TECHNICAL SERVICE BULLETIN

Various Electrical Concerns - Wiring Harness Contacting Coolant Reservoir Bracket - Built On Or Before 20-Nov-2020

21-2219

Ford
2021 F-650/F-750

Figure 2

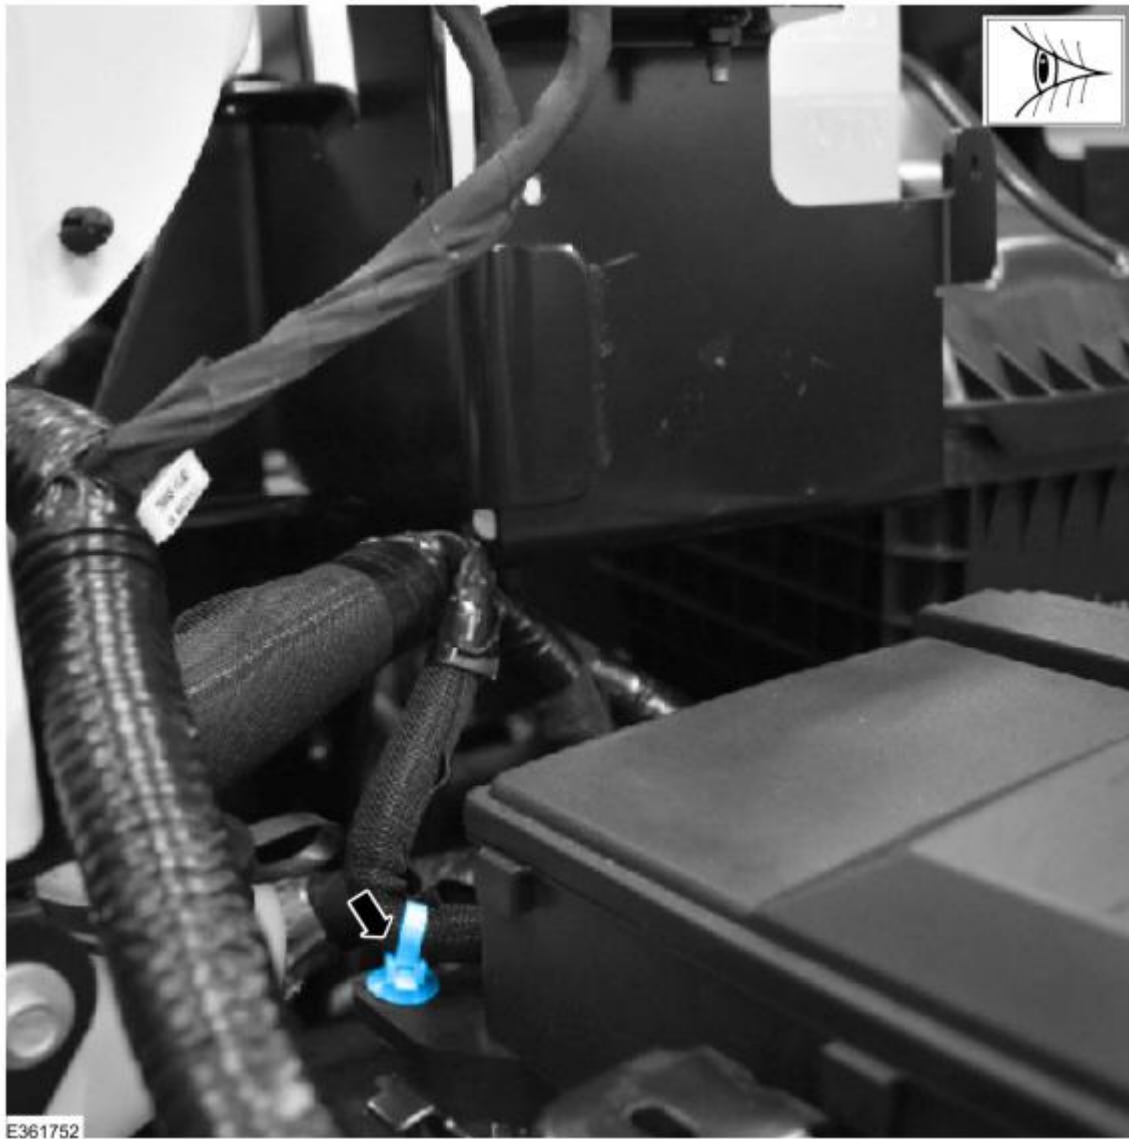
2. Remove the wiring harness retainer from the bracket. (Figure 2)

Figure 3

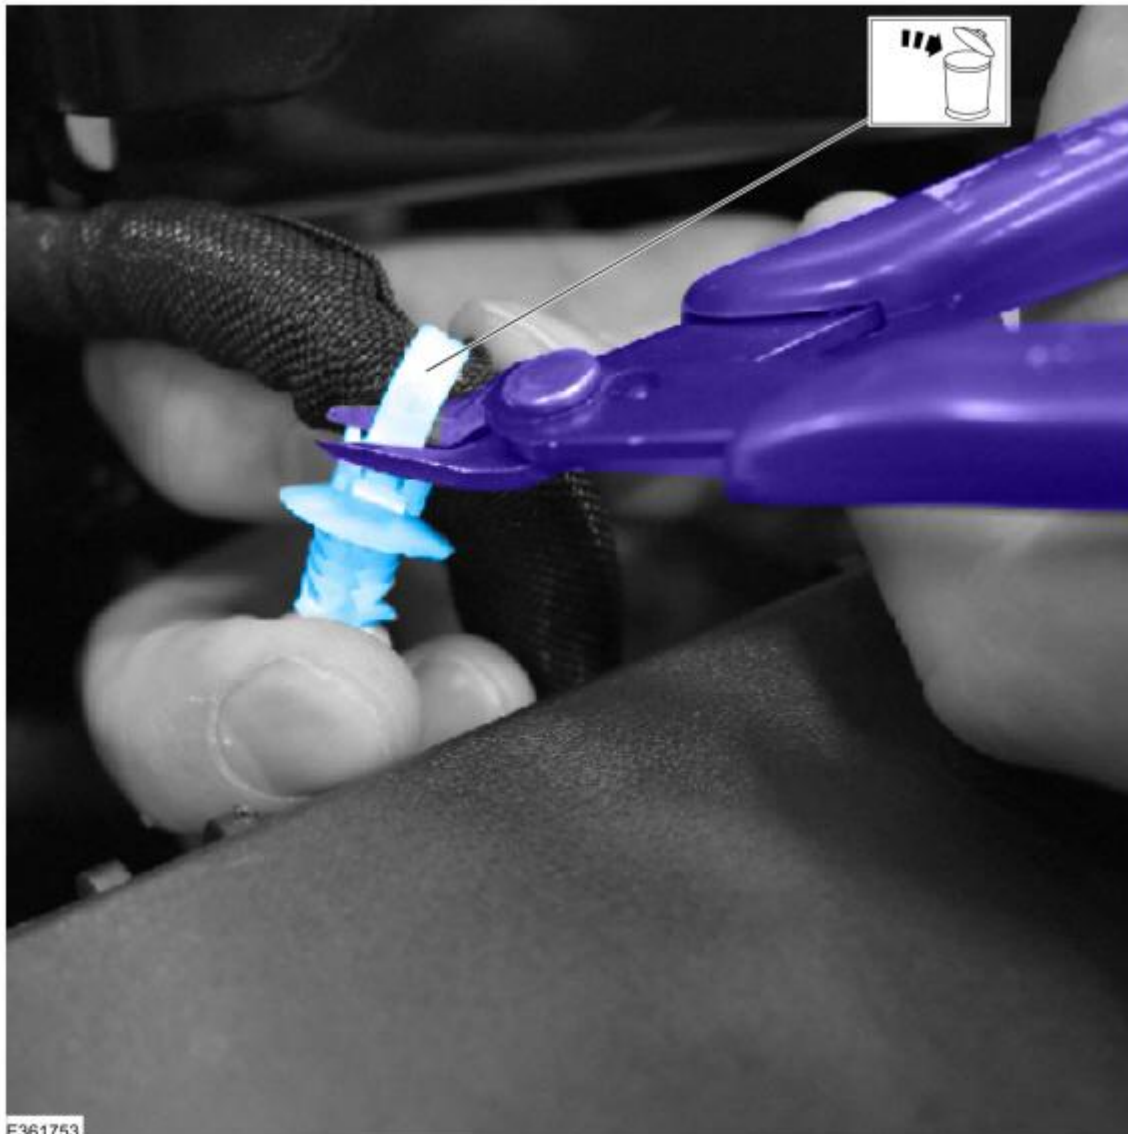
3. Cut the wiring harness retainer off the wiring harness. (Figure 3)

Figure 6

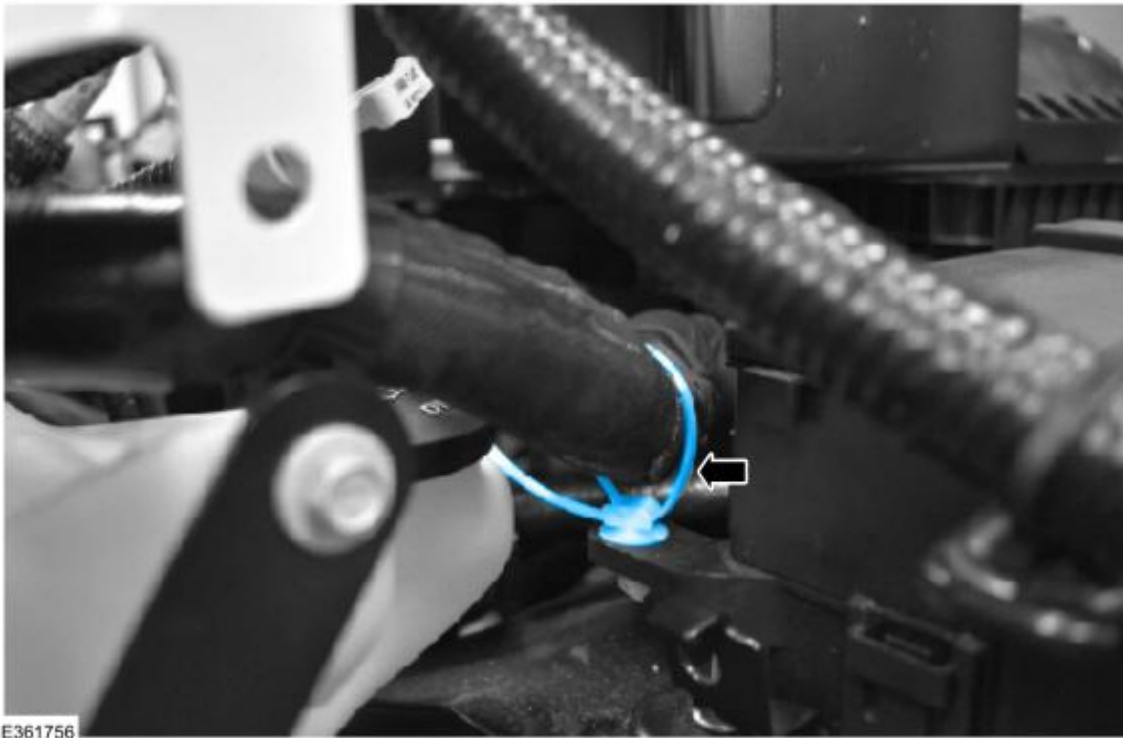
7. Insert the cable tie strap retaining pin into the hole located on the BJB bracket. (Figure 6)

Figure 7

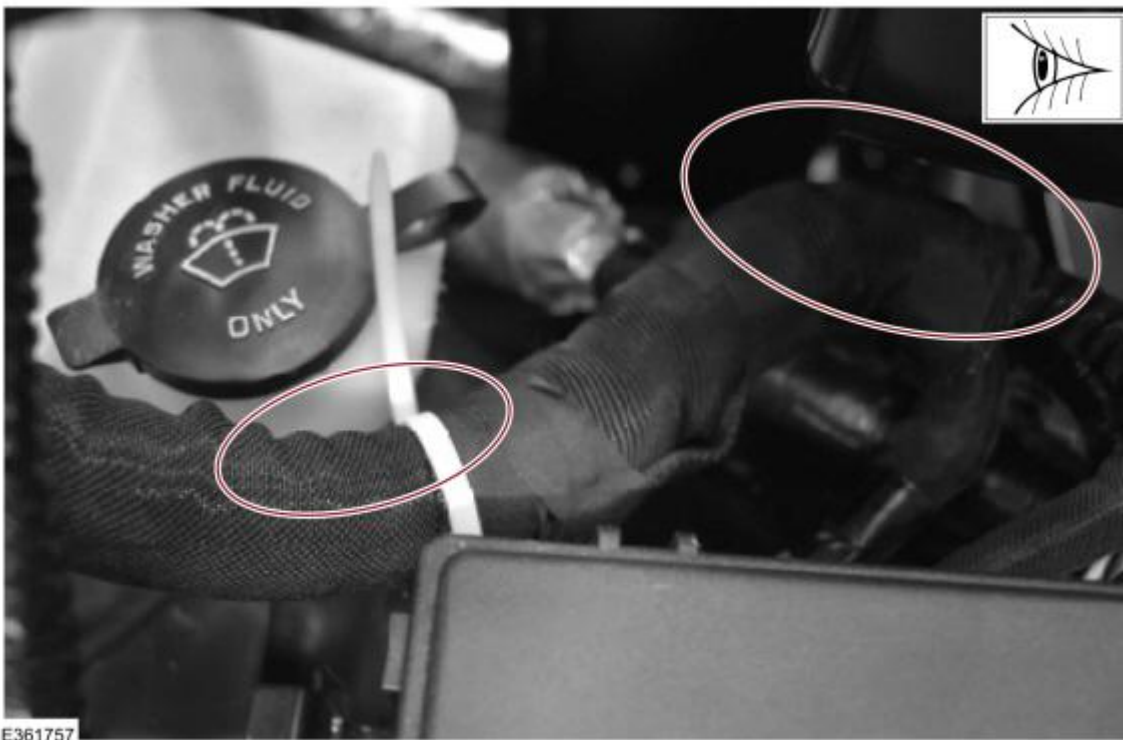
8. Inspect and make sure adequate clearance is present around the wiring harness near the washer fluid reservoir and the coolant reservoir bracket. (Figure 7)

Figure 8

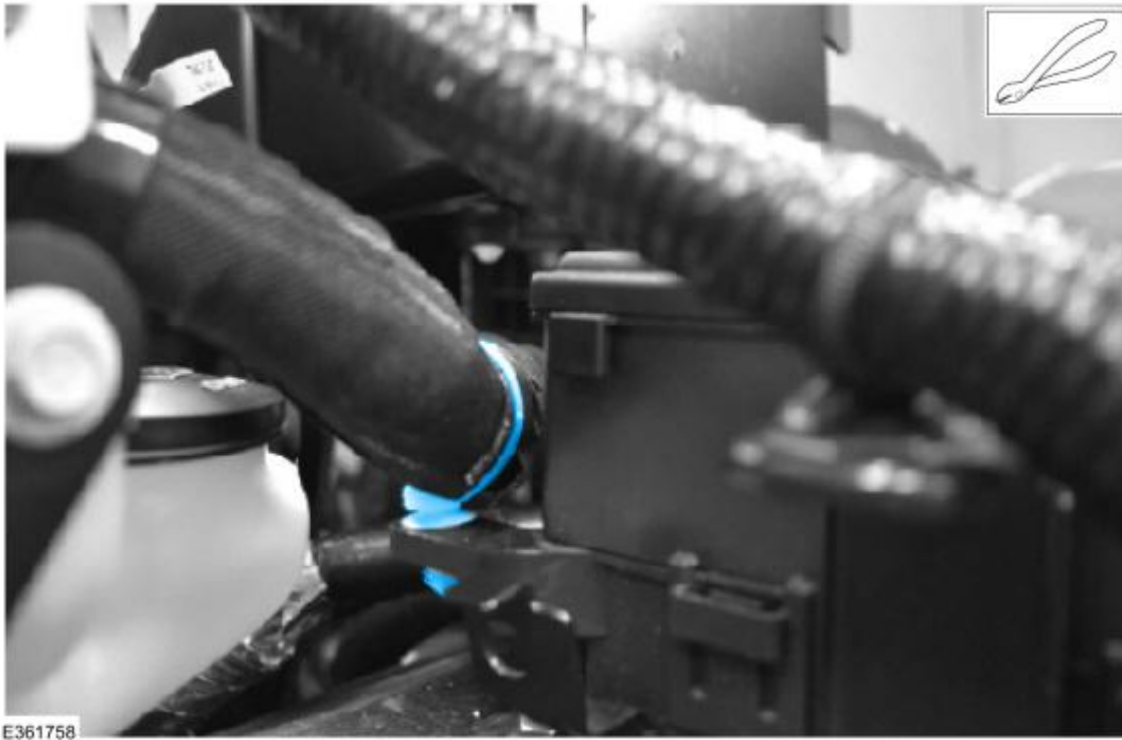
9. Tighten the cable tie strap and trim excess material. (Figure 8)
